ALTAMONT ZONING BOARD OF APPEALS

Regular Meeting Agenda

Village of Altamont Zoning Board of Appeals  
Regular Meeting  
September 27, 2022

This is a pre-application meeting at the request of Troy Miller for subdivision of property at tax map #37.14-3-6.1 into 11 building lots.

COUNTY OF ALBANY  
VILLAGE OF ALBANY  
LANDS OF MILLER  
139 WESTERN AVENUE  
CONCEPT PLAN  
SCALE: 1" = 60'  
FED. 2022-01  
FED. 2022-01

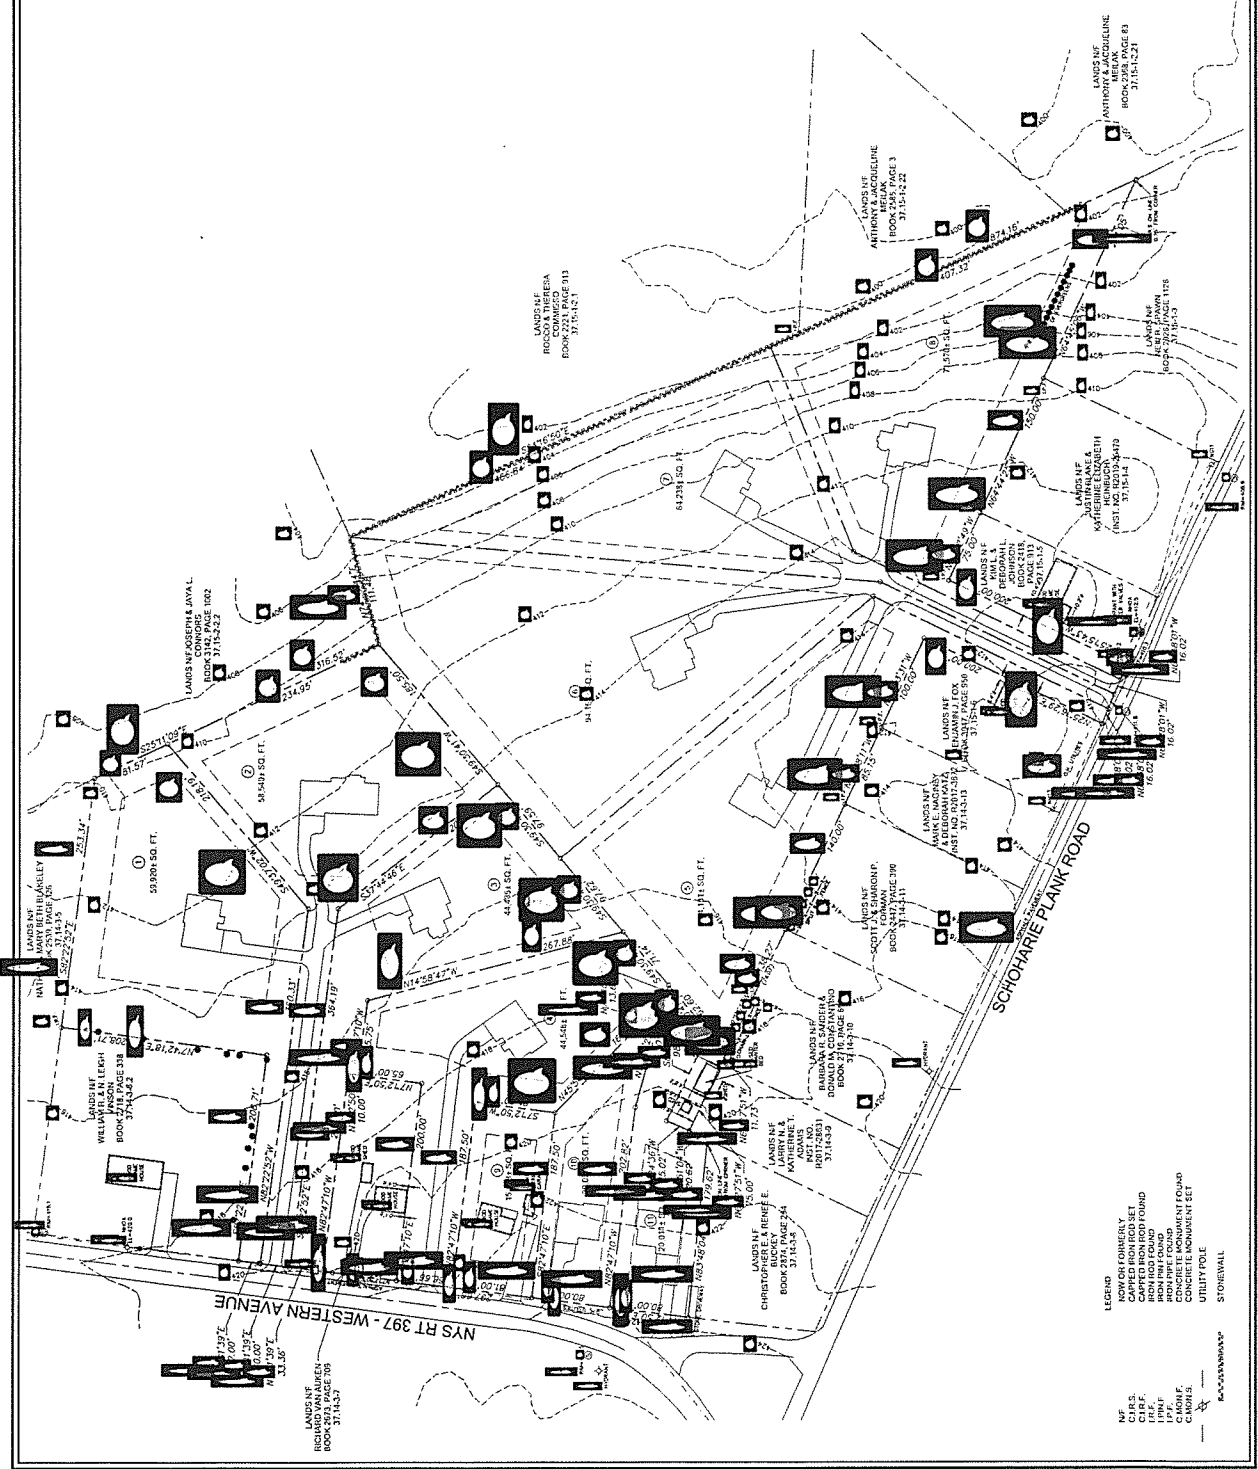
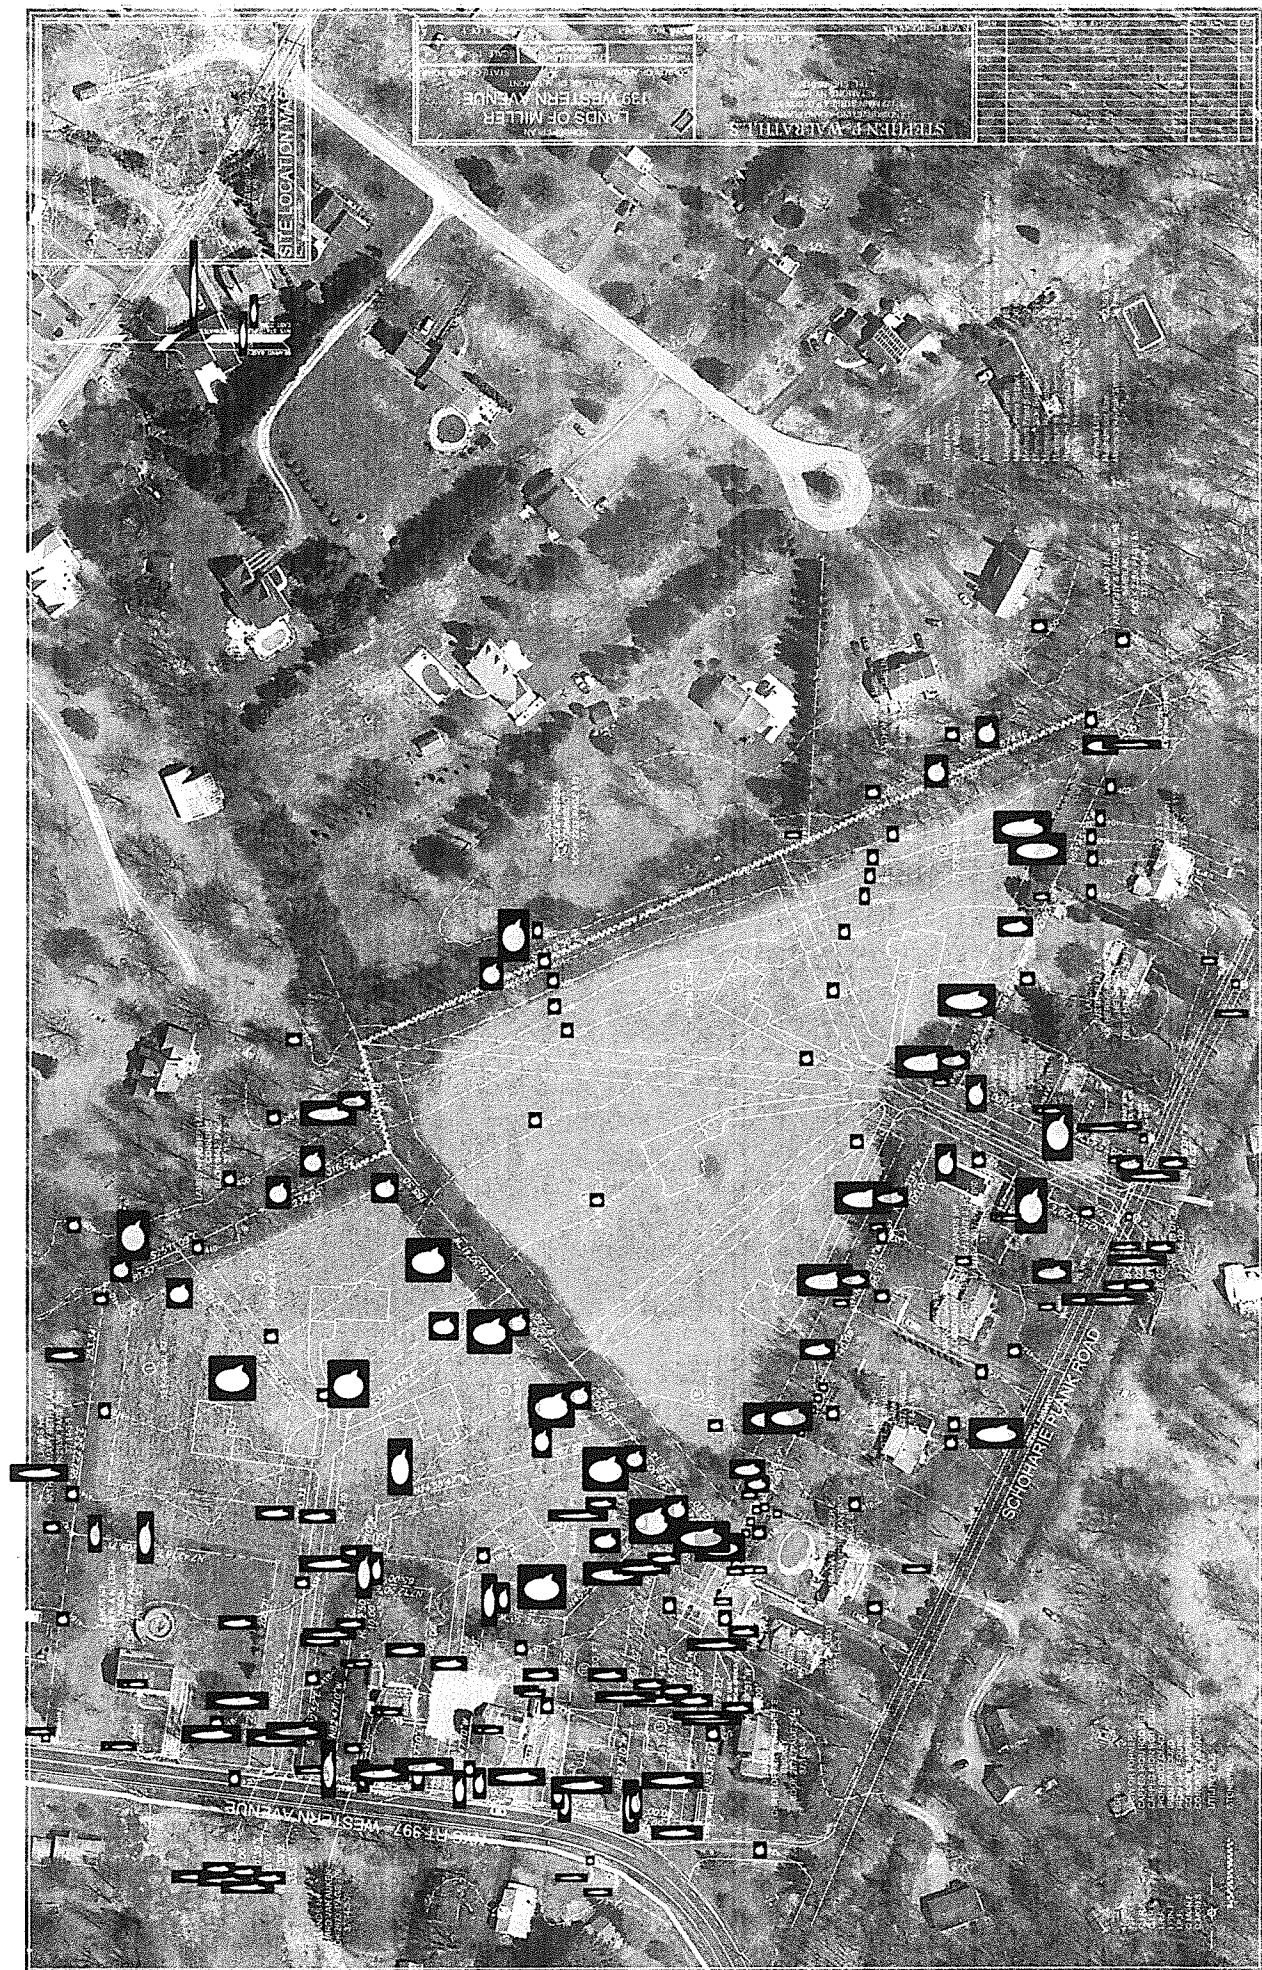
Building Inspector Goss: Both with the access into the properties, below the minimum width of 30 feet, they're going to have to get an area variance for those. In our code, if it's below 30 feet, it's going to be required to have an area variance for any of those lots.

Building Inspector Goss: Yes. I didn't see any notes on the map explaining how the common driveway or access road would work for the four lots off of Schoharie Plank Rd. How would that road be maintained? Or is it going to be part of like a road use agreement or...

Chair Hext: That's one thing that going forward we would need shown on the map.

Board Member Ramirez: Because the speed limit in Village is 30, I don't think that would be a major impact. To consider whether the additional cuts into the highway you know, if it were 45 or better, it's something to consider. On the preliminary plat, when you come back before us, is there a way you could show the site distance?

Mr. Walrath: We're going to revise it and show that as being combined with the lands of Adams. So right now it's shown like it's part of a lot. We're going to draw a line there someplace and say that's not part of a lot. That's just a piece. It's like a lot line amendment, to move the line.

Mr. Walrath: The four parcels would have cross easements to use the 64 foot wide strip. And then there would be a maintenance agreement for the driveway from this portion where they all meet out to Schoharie Plank Road. So the homeowners would be responsible for that, and there's nothing that the Village is responsible for. It would be the same on Western Avenue.

Mr. Walrath: Yes and we would provide legal descriptions of each of the lots and the easements. And then we could get wording put together for the driveway maintenance agreement that you could review and make sure it all it works.

Mr. Walrath: Yes, we can provide that because Western Avenue is a state highway (State Route 397), and that's one of the things that they would require us to give them for a curb cut approval.
